UNITED STATES PATENT AND TRADEMARK OFFICE

Office Action Summary	Application No. 10/560,074	Applicant(s) SCHERB ET AL.	
	Examiner José A. Fortuna	Art Unit 1791

16. The prior art made of record and not relied upon is considered pertinent to applicant's disclosure in the art of "Device for Winding a Tissue Web."

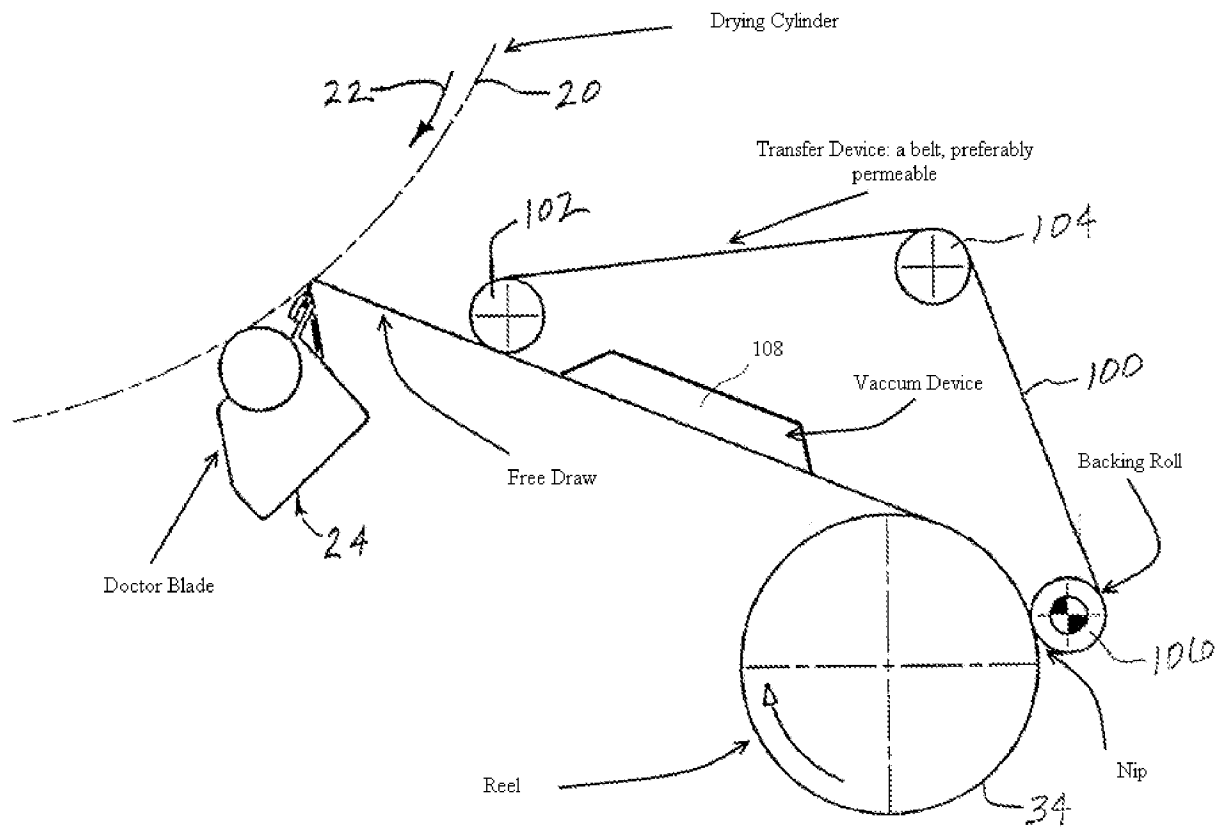
Linden teaches a device for producing a tissue web which includes a drying cylinder that could be a Yankee Dryer, a creping Doctor and winding device to reel-up the web onto a roll and a transfer device that carries the web from almost the entire run from the doctor blade to the winding roll, see figure 7B and ¶-[0053]. The figure shows also that the web is unsupported, creating a free draw from short distance from the doctor to the beginning of the transfer device, and shows that the web is supported on one side of the transfer device. Linden shows also that the device can include a nip, formed by a backing roll and the reel, see for example ¶-[0053]. Figure 7F shows an embodiment in which the web is

formed using a crescent former and through-air-dried (TAD) having hoods. Linden teaches also that the transfer device can be a belt; preferably a permeable belt and that vacuum can be applied to the web through the permeable belt. The device can be a vacuum box or a device that creates under pressure by blowing air via the Coanda effect, ¶-[0053] and Figures 7B and 7C, see below:

Note that Linden shows that the belt moves around a winding drum of the winding device, i.e., moves around the backing roll (106) that form part of the winding device, see figures above, which is/are equivalent to the winding roll 107 of figure 1 of the current application. As to the force at the winding nip, this is functional limitation, which implies that the system is capable and controlled to produce the claimed nip pressure and the system show by the reference, Linden, is inherently capable of producing such pressure at the nip, since it has all the structural limitations of the claim(s). Therefore, the reference anticipates the claims or at least the minor modification(s) to obtain the claimed

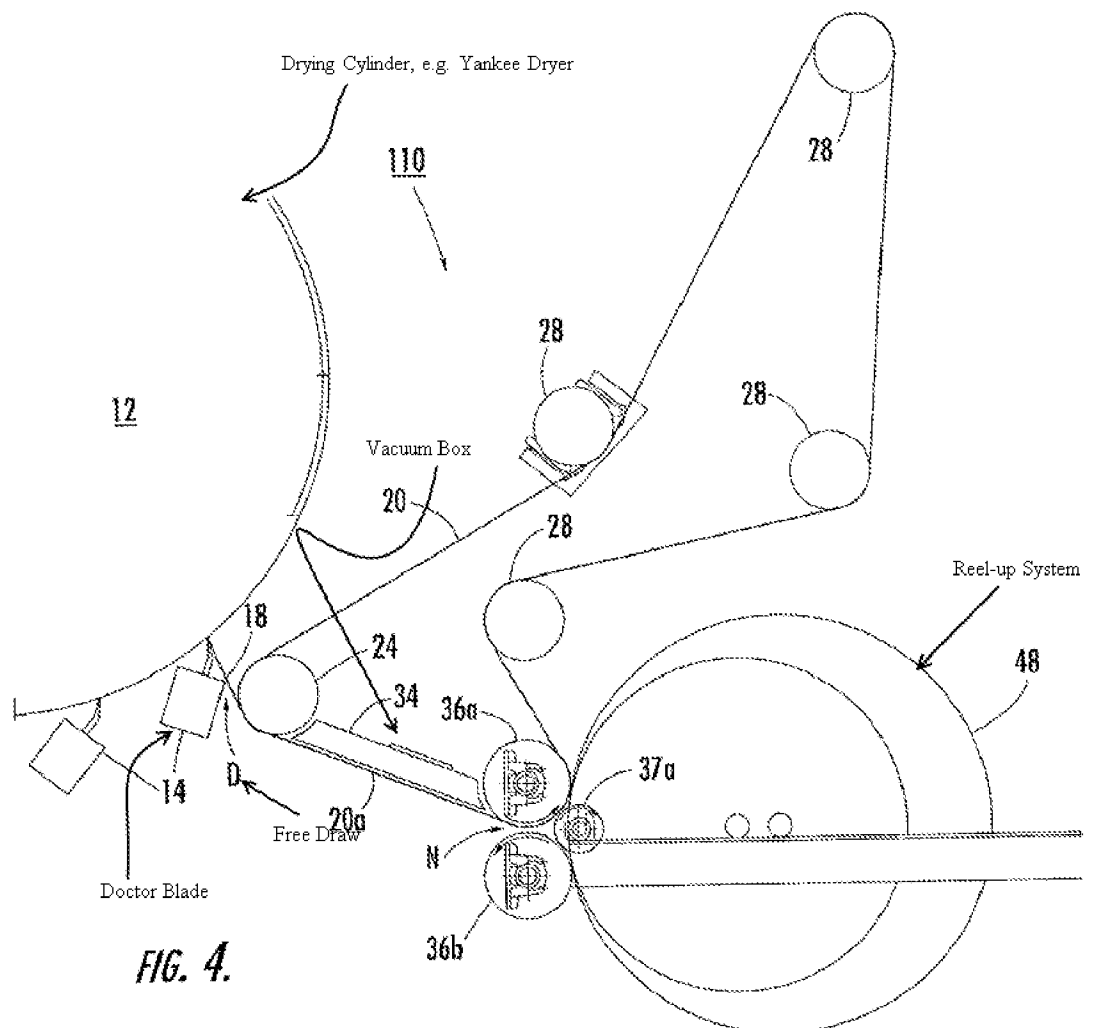
Clarke et al. teach a device for producing a tissue web which includes a drying cylinder, that could be a Yankee Dryer, a creping Doctor and winding device to reel-up the web onto a roll and a transfer device that carries the web from almost the entire run from the doctor blade to the winding roll, see figures, specially figure 4, and ¶-[0036]-[0038]. The figure show also that the web is unsupported, creating a free draw from short distance from the doctor to the beginning of the transfer device, and show that the web is supported on one side of the transfer device. Clarke teach also that the short Draw, (D) can be changed from 4 inches to 48 inches, (0.1 to 1.20 meters), which falls within the claimed range, see ¶-[0024]. Clarke et al. show also that the device can include a nip formed by a backing roll and the reel, figure 4, and ¶-[0036]-[0038]. Clarke et al. teach also that the transfer device can be a belt; preferably a permeable belt and that vacuum can be applied to the web through the permeable belt. The device can be a vacuum box (34) or a device that creates under pressure by blowing air via the Coanda effect, ¶-[0030]-[0033] and Figures 4, below:

Note that Clark et al. show that the belt moves around a winding drum of the winding device, i.e., moves around the backing roll (36a) that form part of the winding device, see figure above, which is/are equivalent to the winding roll 107 of figure 1 of the current application. As to the force at the winding nip, this is functional limitation, which implies that the system is capable and controlled to produce the claimed nip pressure and the system show by the reference, Clark et al., is inherently capable of producing such

**FIG. 5**

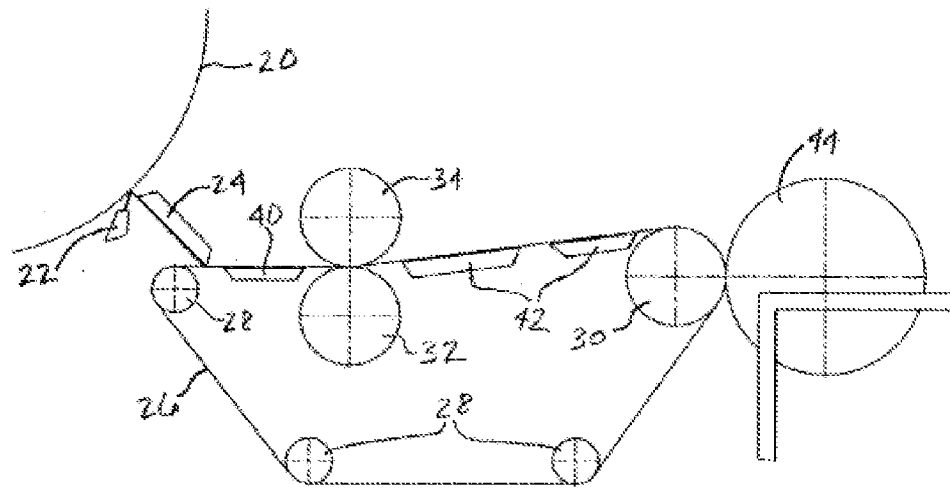
Klerelid et al. teach a device for producing a tissue web which includes a drying cylinder, that could be a Yankee Dryer, a creping Doctor and winding device to reel-up the web onto a roll and a transfer device that carries the web from almost the entire run from the doctor blade to the winding roll, see figures 1-21 and ¶-[0005]-[0014]. The figures show also that the web is unsupported, creating a free draw from short distance from the doctor to the beginning of the transfer device, and shows that the web is supported on one side of the transfer device. Klerelid et al. show that the device can include a nip, formed by a backing roll and the reel, see for example figure 21, and ¶-[0069]. Klerelid et al. teach that the lineal pressure at the winding nip is controlled to be between 100-250 N/m (0.1 kN/m- 0.250 kN/m), ¶-[0071]. Klerelid et al. teach also that the transfer device can be a belt; preferably a permeable belt and that vacuum can be applied to the web through the permeable belt. The device can be a vacuum box or a device that creates under pressure by blowing air via the Coanda effect, ¶-[0040] and Figures 1-21, see figure 5 below:

Note that Klerelid et al. show the belt moves around a winding drum (**30**) of the winding device, i.e., moves around the backing roll that form part of the winding device, see figures above, which is/are equivalent to the winding roll **107** of figure 1 of the current application. As to the force at the winding nip, even though Klerelid teaches that the pressure at the nip is preferably maintained between 0.1 to .25 kN/m, the system is capable to be controlled to produce the claimed nip pressure , i.e., the system is inherently capable of producing such pressure at the nip, since it has all the structural limitations of the claim(s). Therefore, the reference anticipates the claims or at least the minor modification(s) to obtain the claimed invention, i.e., to apply the claimed nip pressure, would have been obvious to one of ordinary skill in the art.
